service bulletin

No. 91-32

Sta-Strap Interference with Throttle Cable Sleeve – 1992 75 thru 115

S/N 0D096367 thru 0D107109

Sta-Strap Locking Tab Contacting Throttle Cable Sleeve

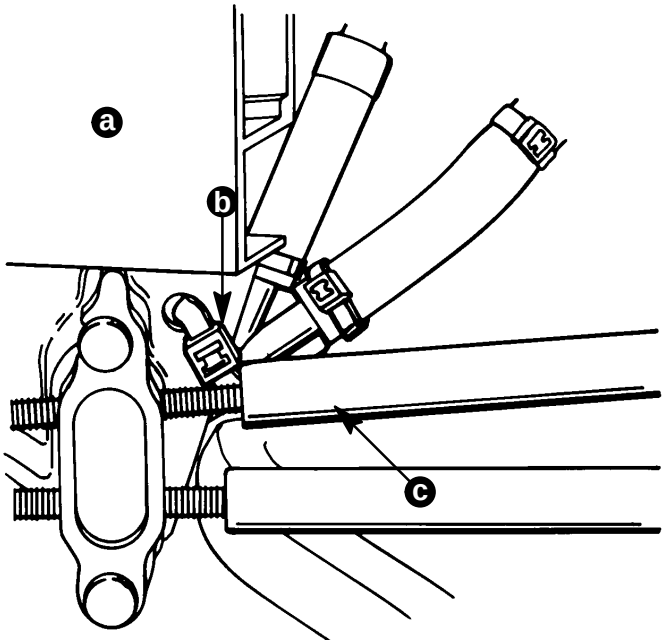
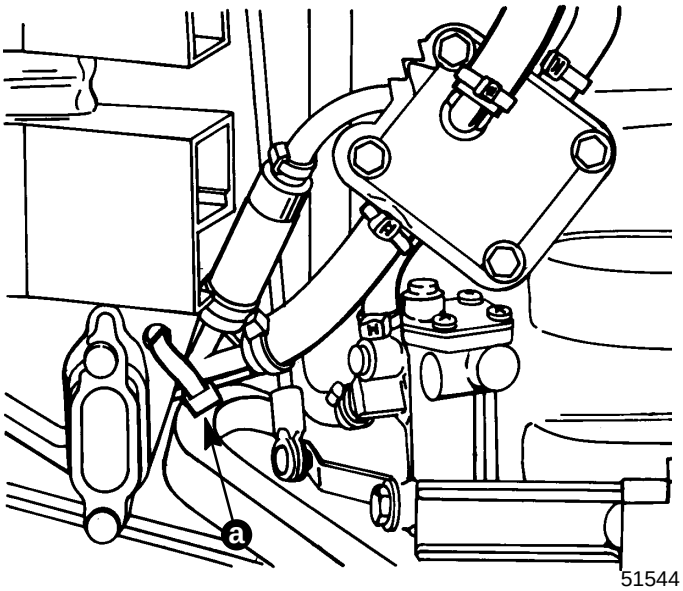
Inspect the sta-strap that holds the fuel line to the carburetor air intake. If the sta-strap locking tab is pointing straight out, it may contact the throttle cable sleeve at full throttle. This contact may prevent full throttle operation.

Turn the sta-strap until the locking tab is down and can not contact the throttle cable sleeve.
